From: Karen Beare [REDACTED]
Sent: 18 June 2019 21:26
To: Thuaire, Charles [REDACTED]
Cc: Harley Atkinson [REDACTED]; Kathy Lambie [REDACTED];
Medhi Norowzian [REDACTED]; Majid Saadati [REDACTED]; Steve Barber
[REDACTED]; John Kennedy [REDACTED]
Subject: 2019/2584/P - Water House Boundary with 51/53 and Fitzroy Park

Two small points, on Page 11 of 17007-Water House Planning Application Drawings 2019 06 03-1.pdf it incorrectly states No 53 Fitzroy Park boundaries the Water House on Millfield Lane, when it is the Wallace House. And in the Agent's application form, it wrongly states the pedestrian entrance will not be changed. I've provided a screen shot of this statement.

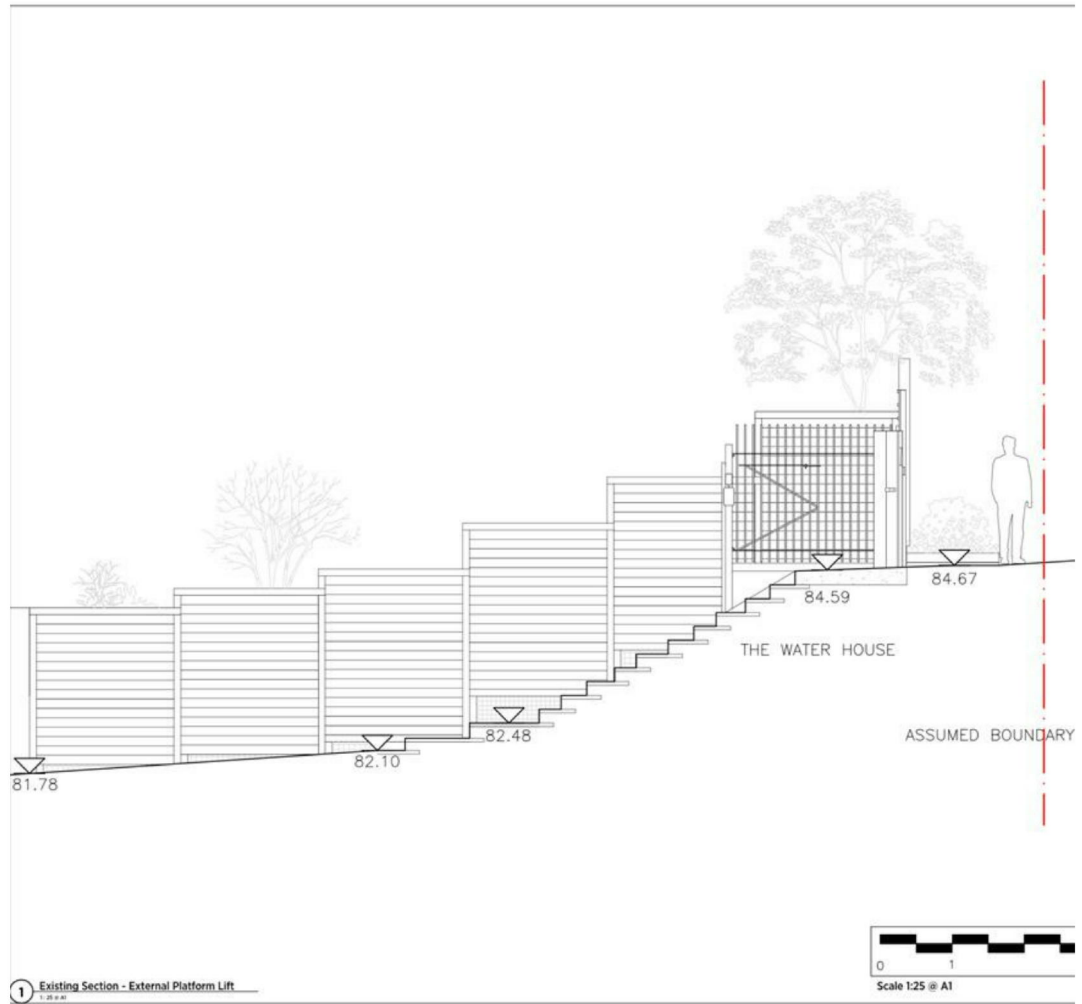
- when you compare cross-section drawings 17007-P004A vs 17007-P008A (as per screen shots below) you can see the existing level difference of 2.6m will change from a gradual stepped incline, to a sharp vertical up/down to accommodate the new lift.

- the drawings show at least 2/3 fence panels bays along Mr & Mrs Norowzian's boundary will need to be increased quite significantly. We are assuming the appropriate discussions/agreements have been put in place, and they are content with these proposals.

- we note however, these drawings do not appear to show the other side of this narrow pedestrian access and would ask exactly how will the significant level change being proposed, be handled with Mr Saadati boundary at No53 Fitzroy Park?

- and from an FPRA perspective, how will any changes (not shown) to fencing with the No53 Fitzroy Park "side" of the pedestrian access, interface with the front boundary along Fitzroy Park? This needs to be clarified please.
